AERONAUTICAL CHARTING FORUM
Charting Group
Meeting 09-01 – April 29-30, 2008

RECOMMENDATION DOCUMENT

FAA Control # 09-01-215

Subject: Reporting & Depiction of Stopway

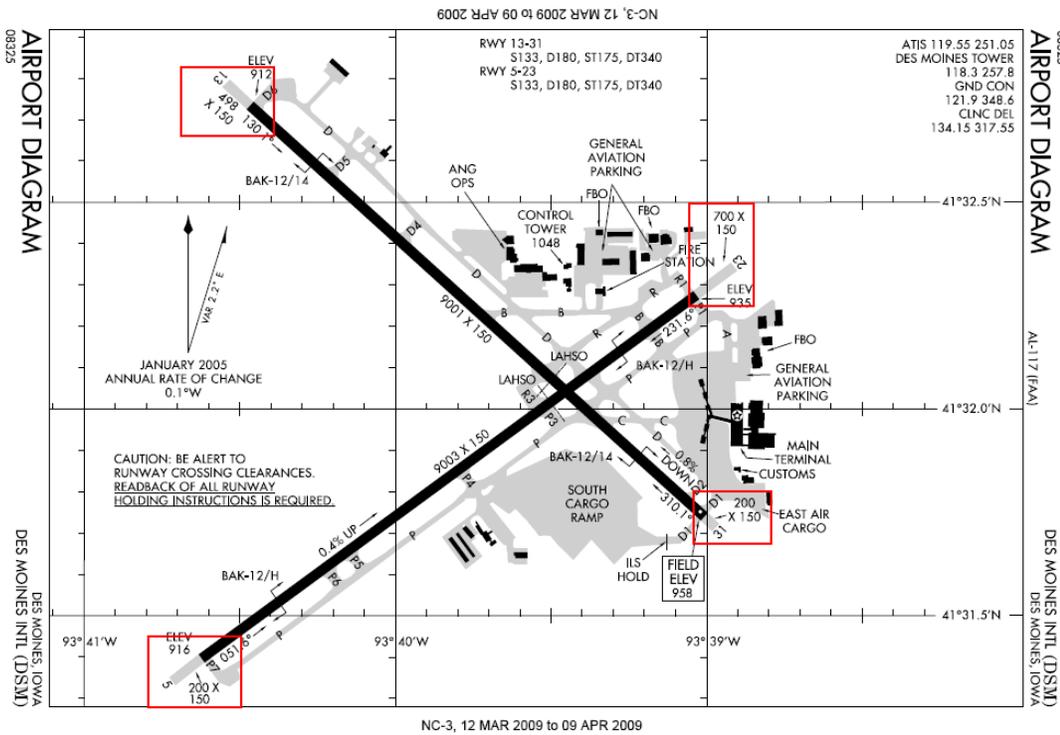
Attention is called to item 2(b)'s reference to "overruns". An overrun is a term applied strictly to military runways as defined in the AIM's Pilot/Controller Glossary:

Further, the term "overrun" is not used in AC 150/5300-13, Airport Design to describe any surface component of a runway. Therefore, the use of the term "overrun" in Order 7910.4C may be inconsistent with the stated purpose of this Order:

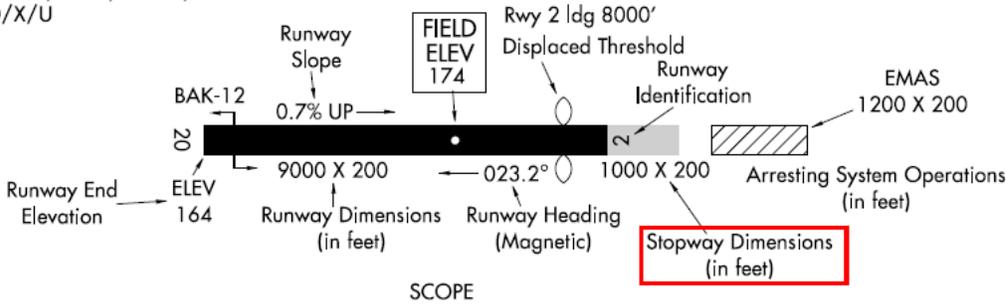
In reference to the TPP Airport Diagram Legend when a depicted area beyond the end of the runway contains dimensions, the area in question is identified as a stopway:

If the DSM A/FD entry is cross-checked against the above Airport Diagram, we find that the stopway length and associated declared distances for each runway have not been recorded as required by AC 150/5300-13 paragraph 309:

Since the introduction of this agenda item, AeroNav/NACO has modified the legend of the Terminal Procedures Publication, removing the “stopway dimensions” from the pavement extensions beyond the end of the runway. This action eliminates one source of confusion regarding whether the extension is a stopway absent corresponding published declared distances information in the AFD. This action satisfies the agenda item’s recommendation #5.

The DSM Airport Obstruction Chart (Jan 2005) was also referenced to determined the validity of the stopway designation. Excerpts from the DSM's OC chart show the areas in question depicted as blast pads:

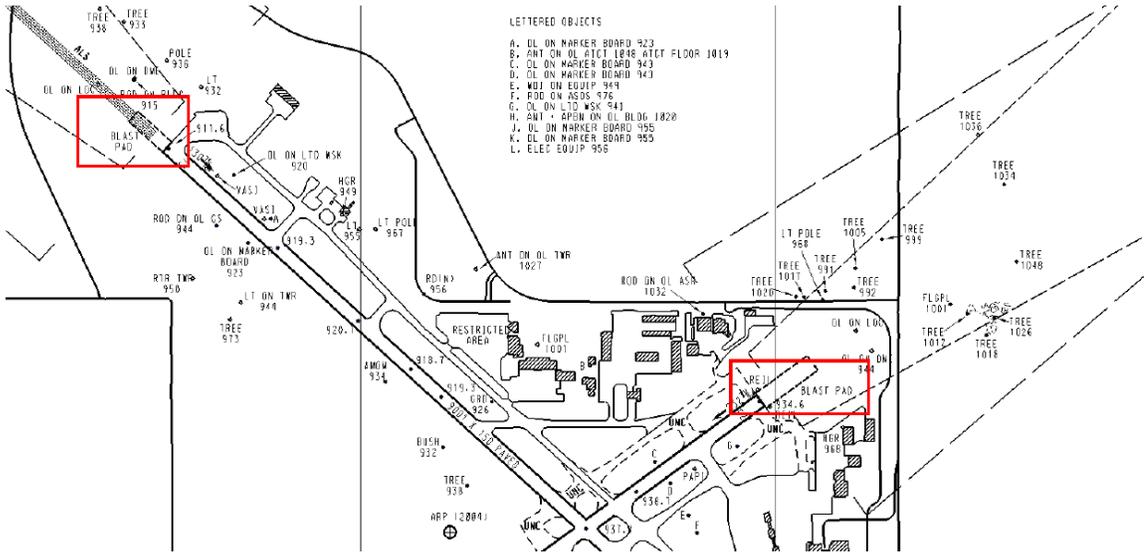
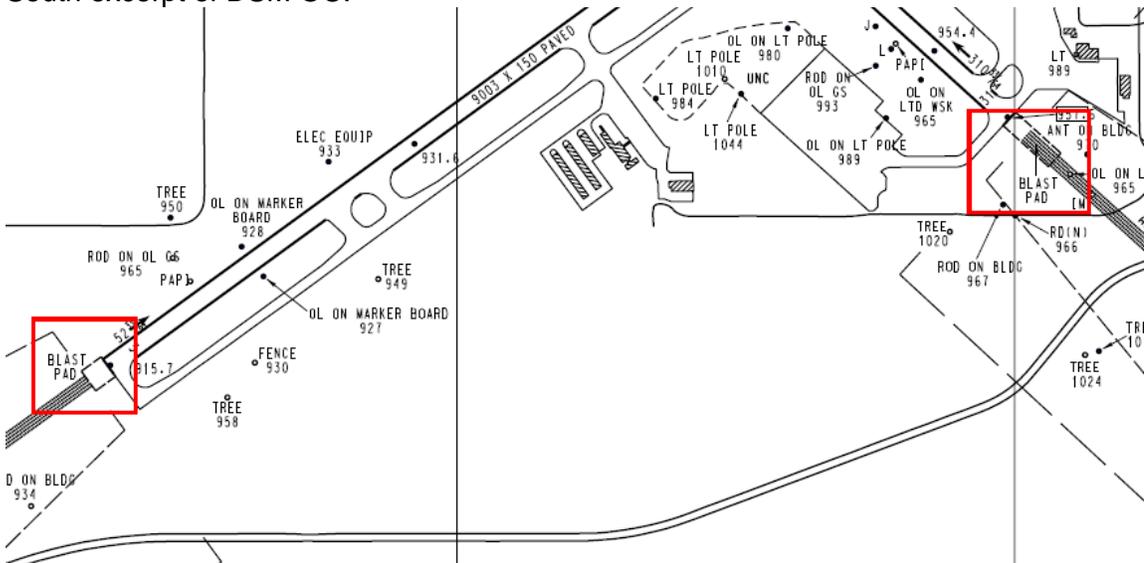
The DSM OC's depiction of these areas as blast pads is supported by the information contained in the DSM's NGS Aeronautical Data UDDF file. The first line below the runway heading element records the known status of a blast pad for that runway. For DSM's runways, the blast pad status record is as follows:

The NGS Aeronautical Data UDDF file supports the DSM OC's designation of these areas as blast pads.
